ADDENDUM NO. 1

RE: HIGH SCHOOL #13

Howard County Public School System

Bid Number: 016.20.B4

dwg
 ADD_1 P6

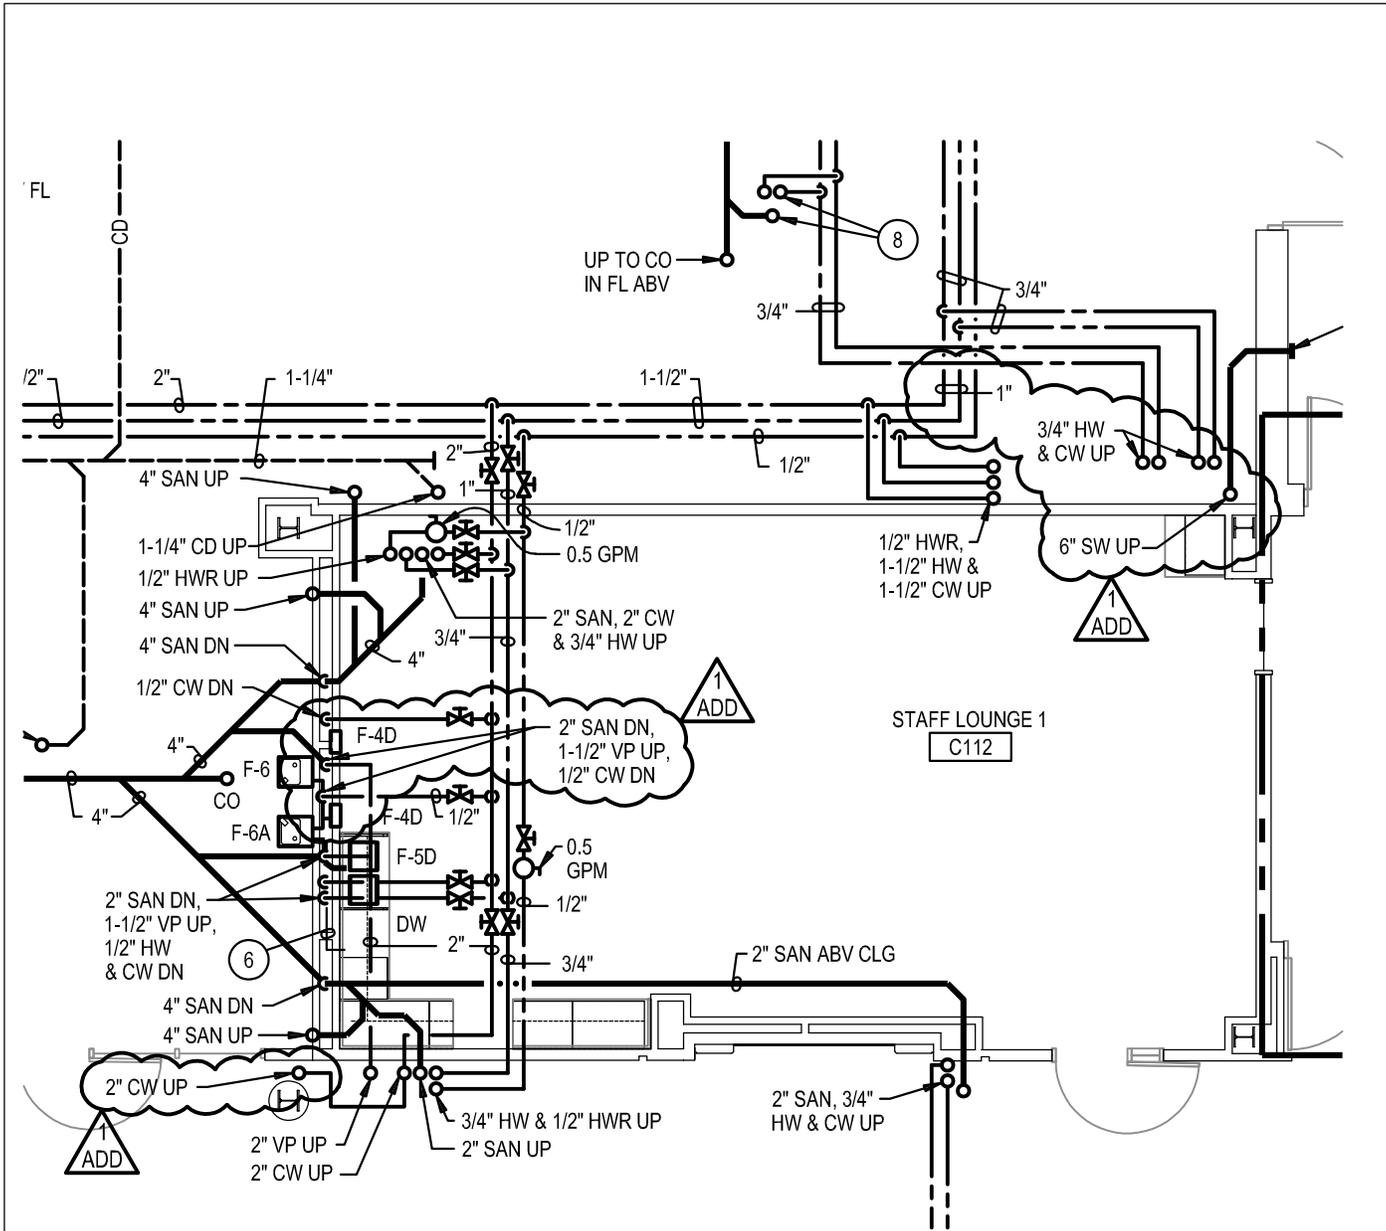
ADD Piping to can wash per sketch ADD_I_P6.

dwg
 ADD_1 P7

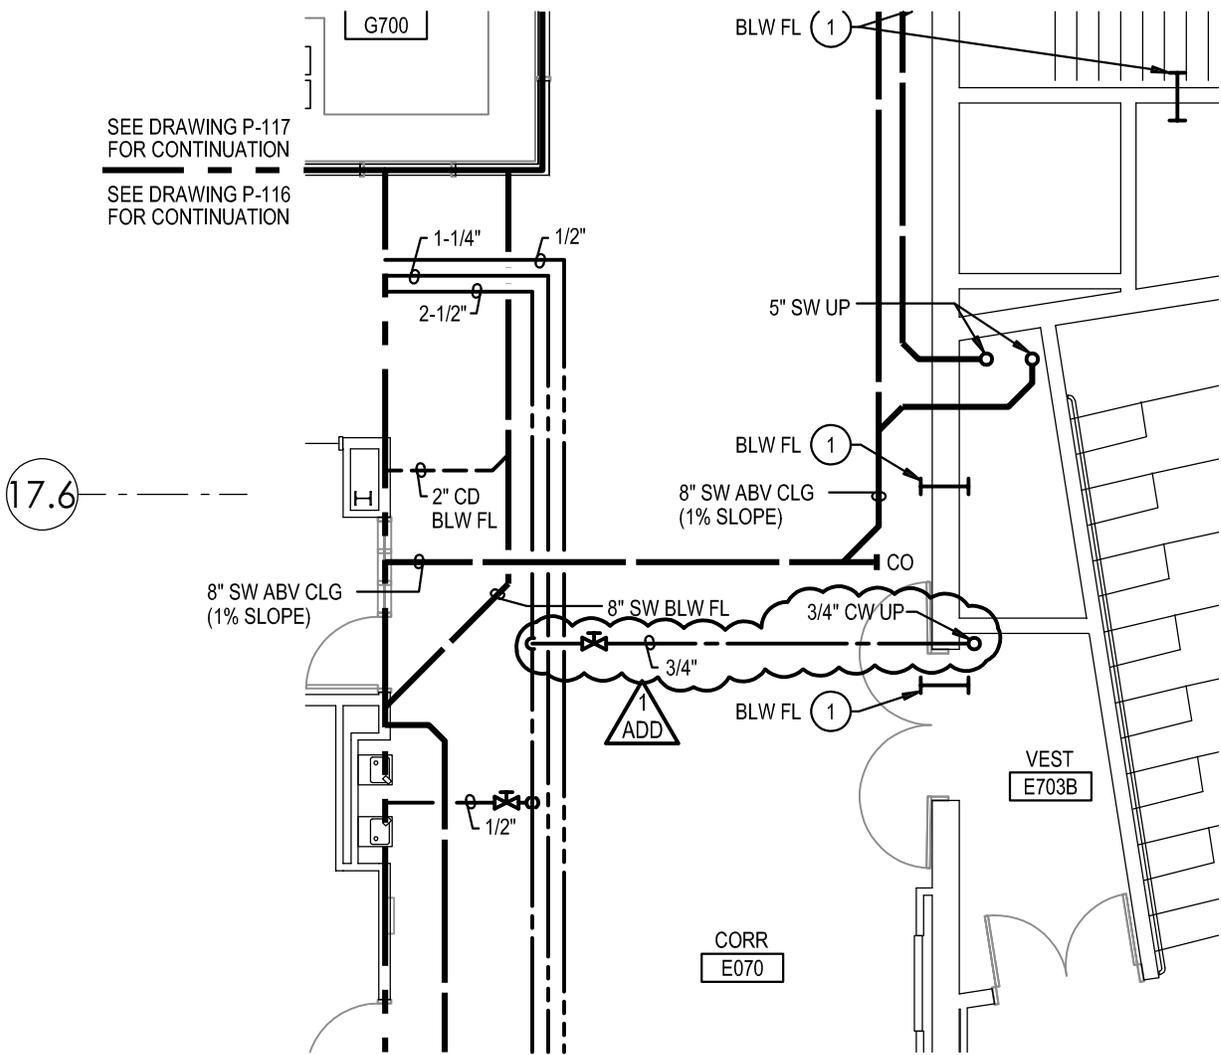
ADD Notes per sketch ADD_I_P7.

dwg
 ADD_1 P8

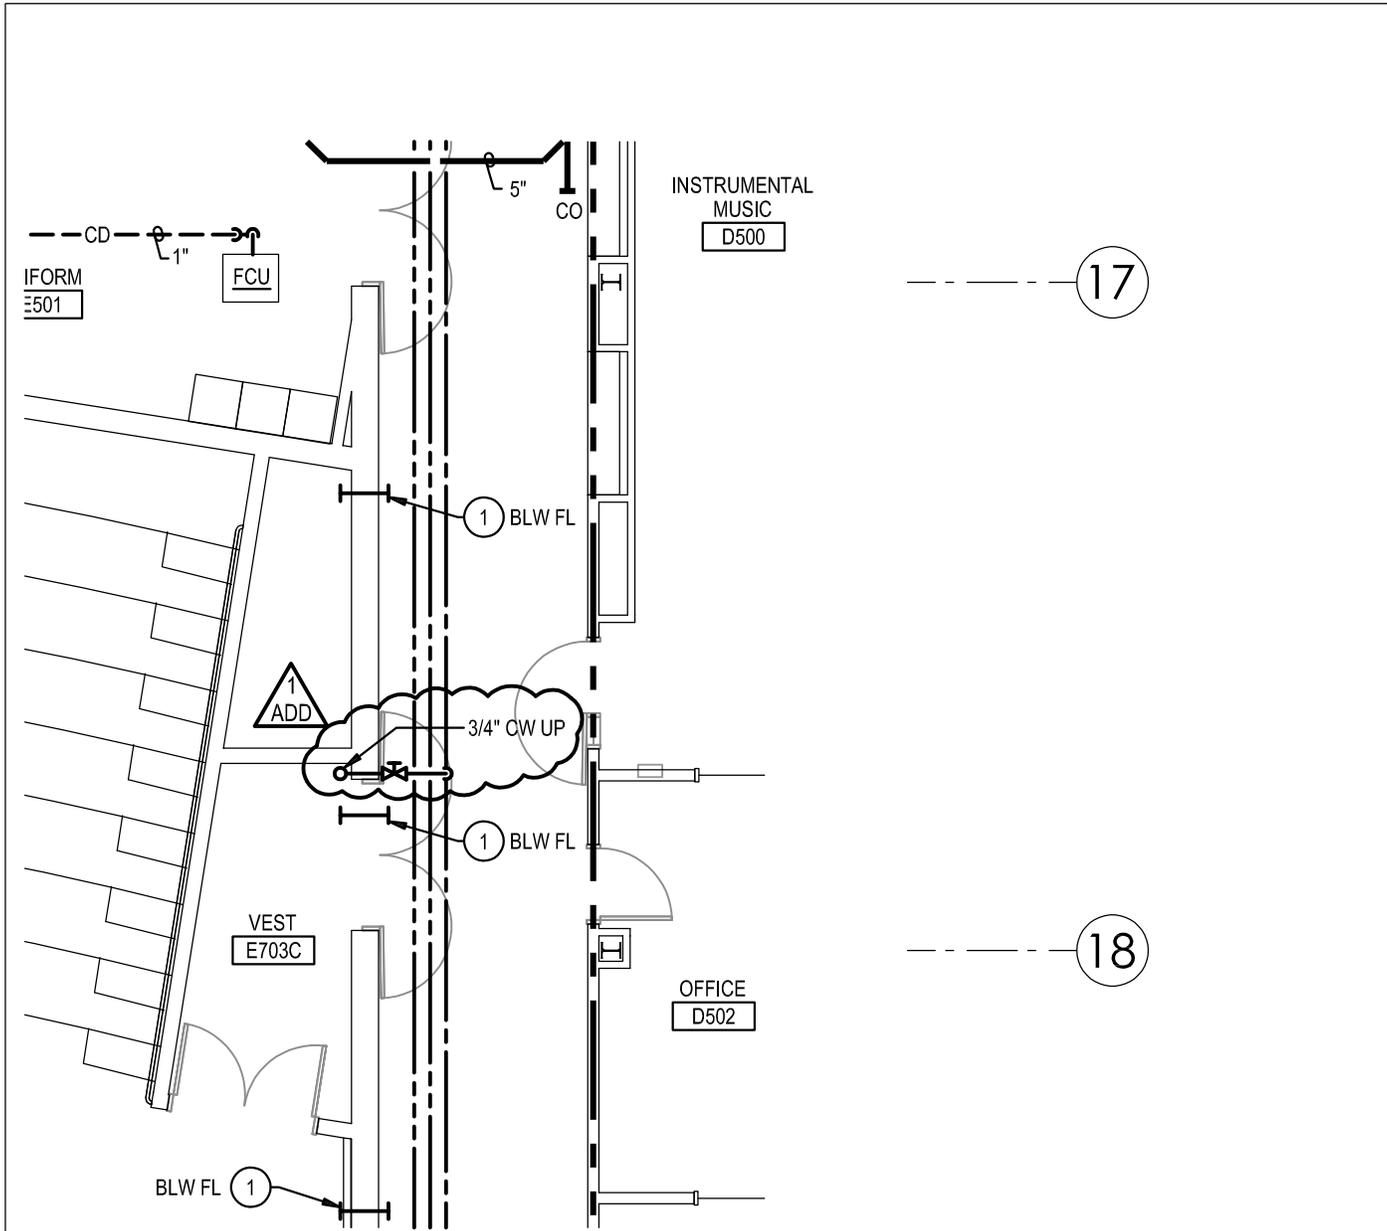
ADD Cold water pipe for wall hydrant per sketch ADD_I_P8.

dwg
 ADD_1 P9

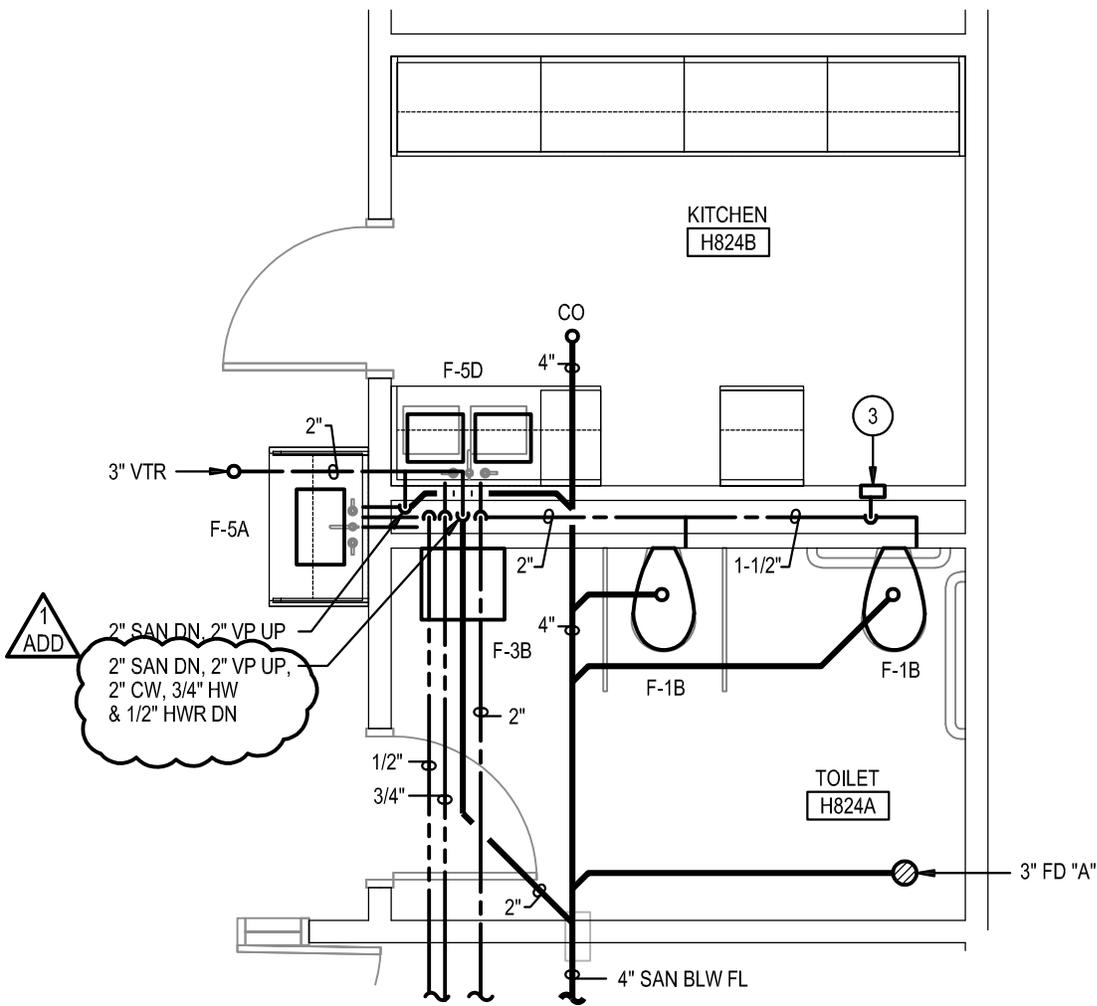
ADD Cold water pipe for wall hydrant per sketch ADD_I_P9.

dwg
 ADD_1 P10

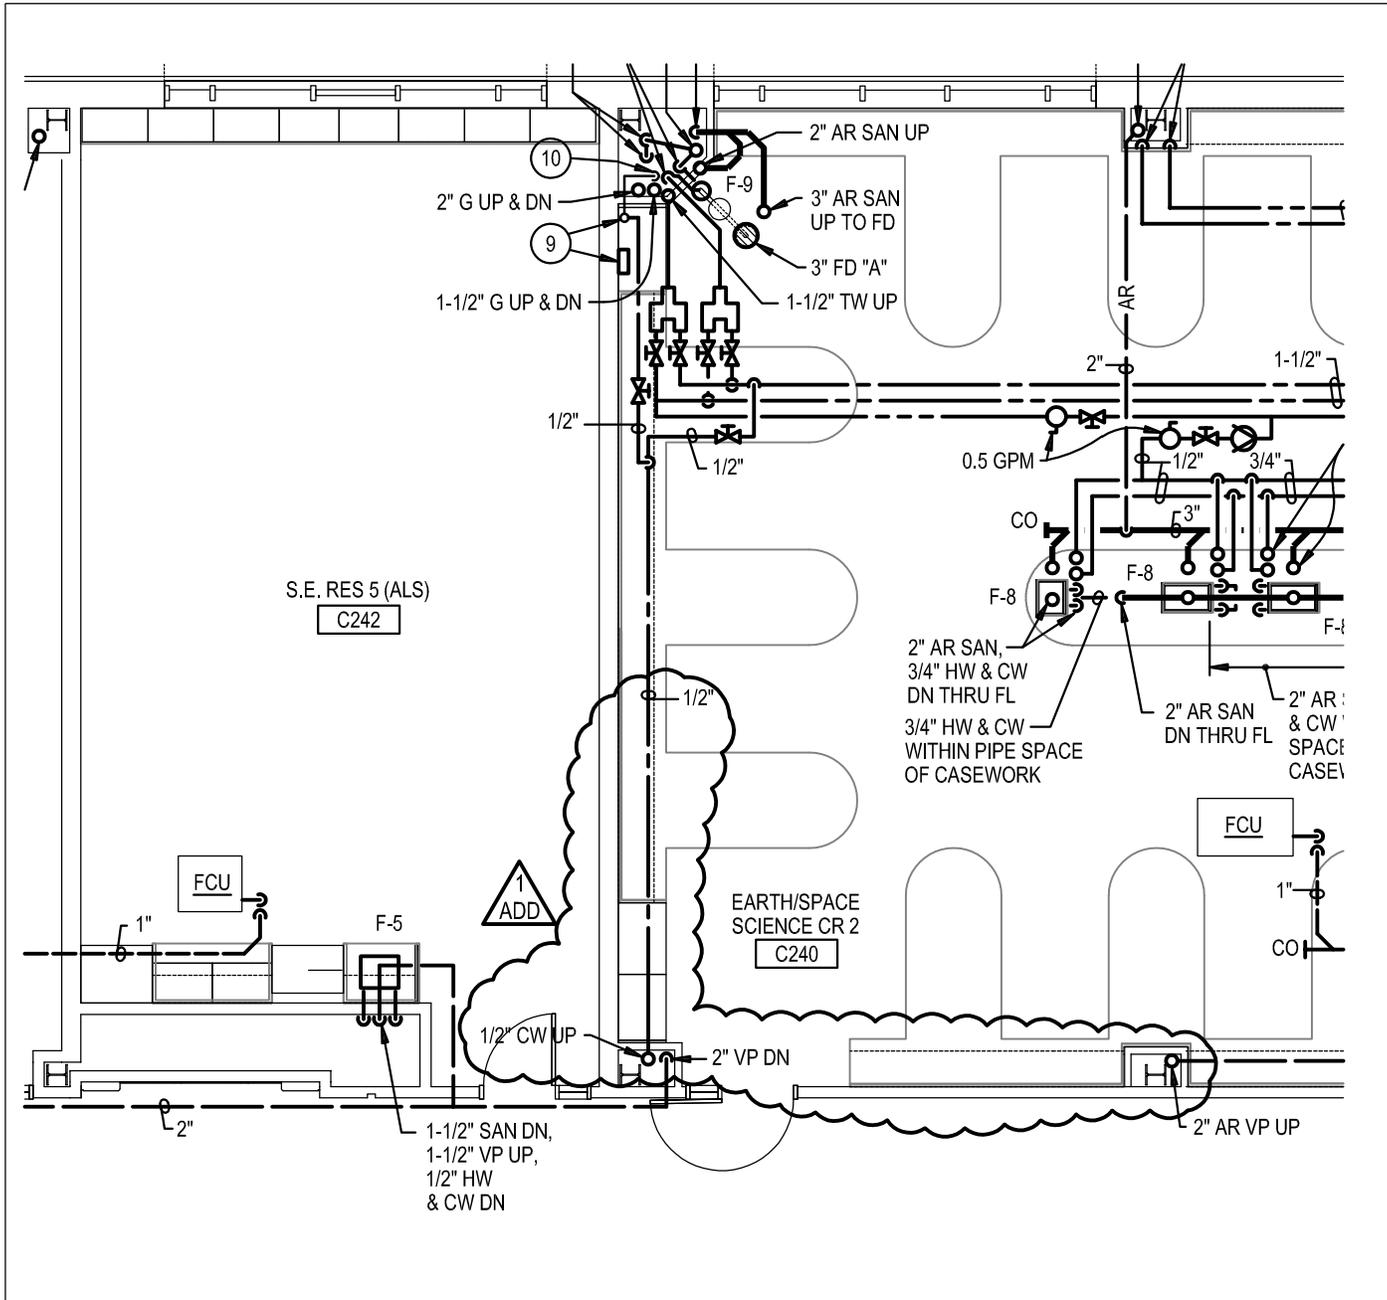
REVISE Pipe size per sketch ADD_I_P10

dwg
ADD_1 P12

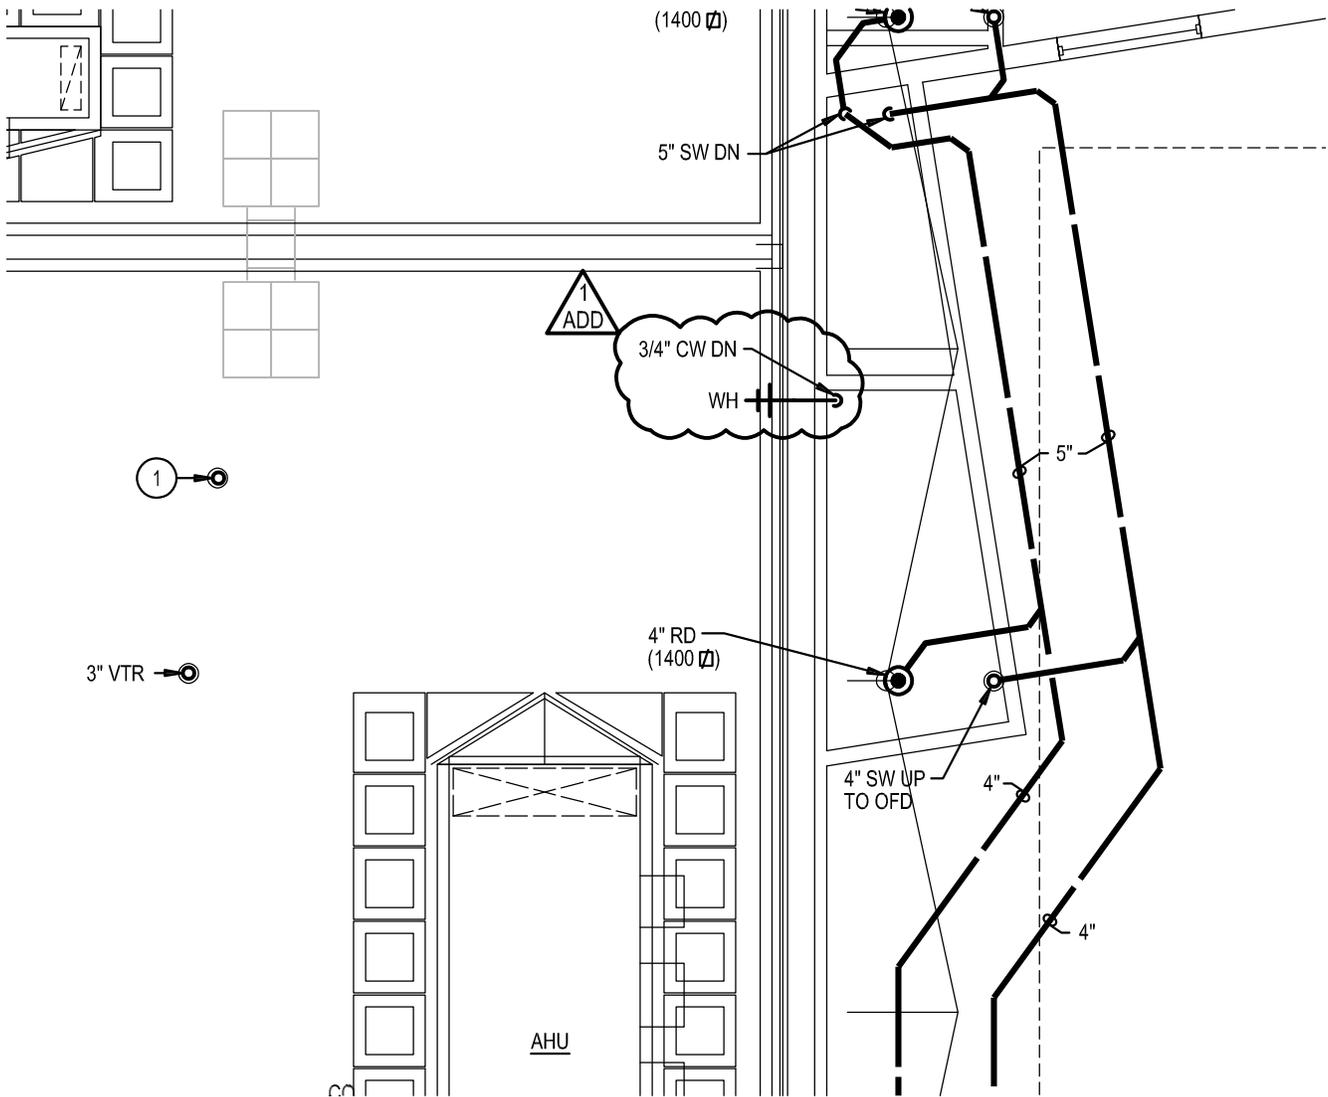
ADD Notes per sketch ADD_I_P12.

REMOVE Vent piping per sketch ADD_I_P12.

dwg
 ADD_1 P13

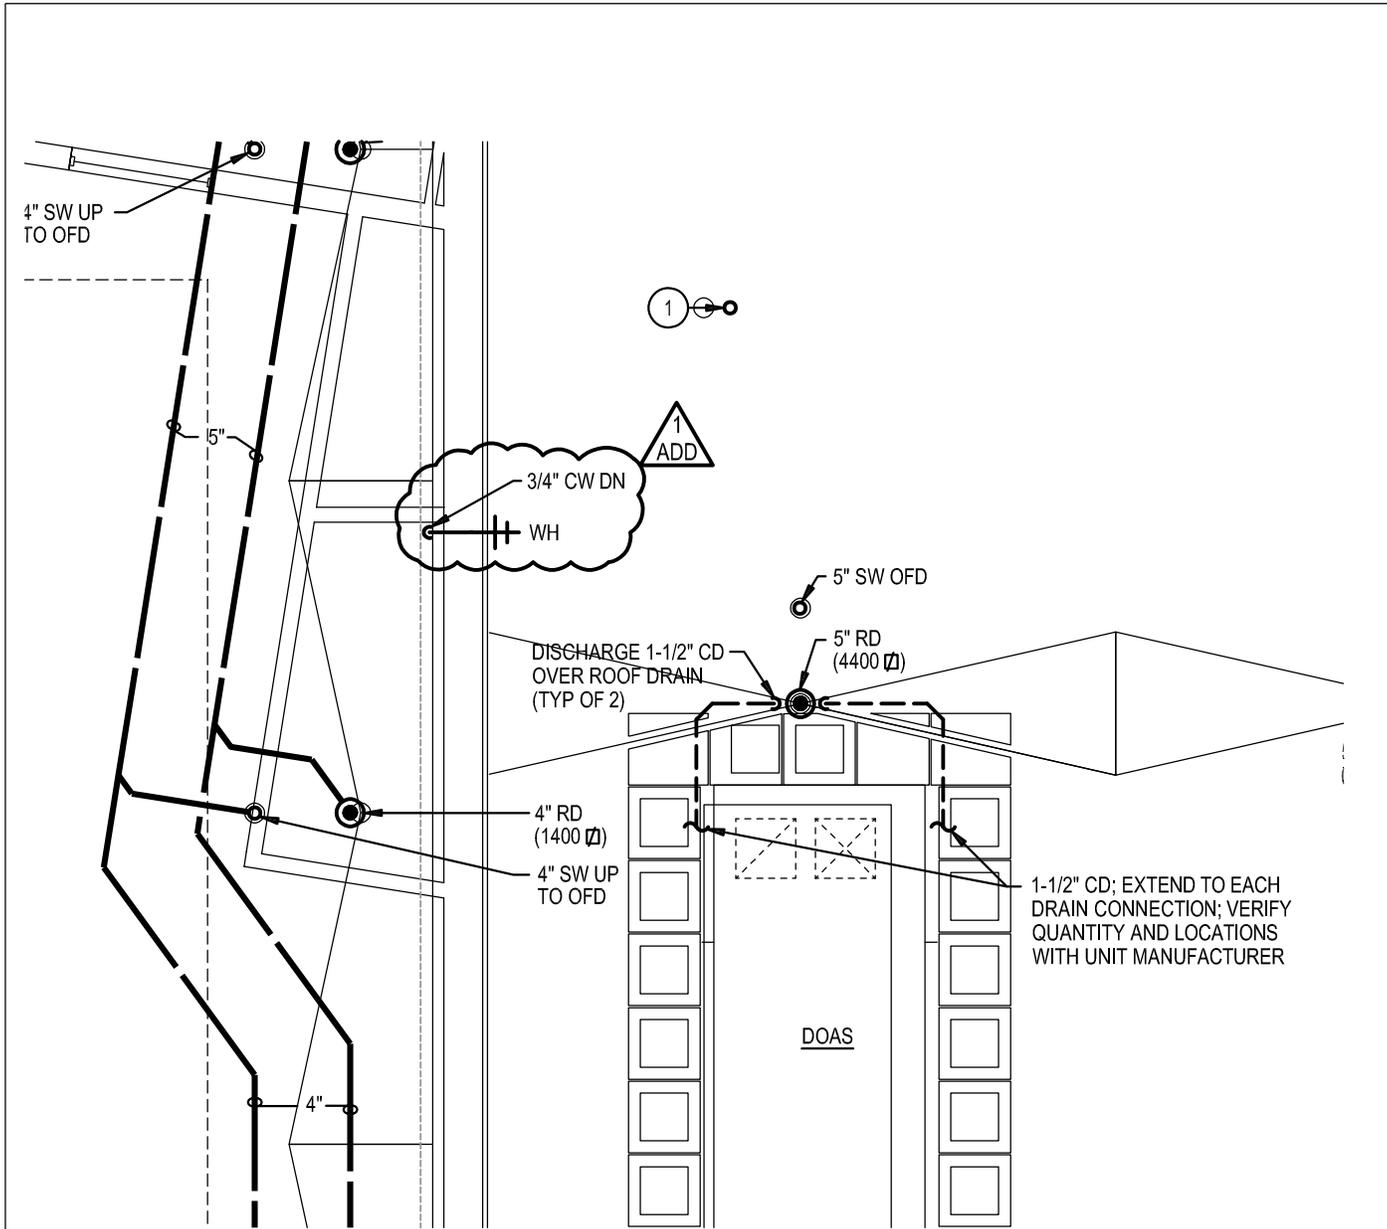
ADD Wall hydrant per sketch ADD_I_P13.
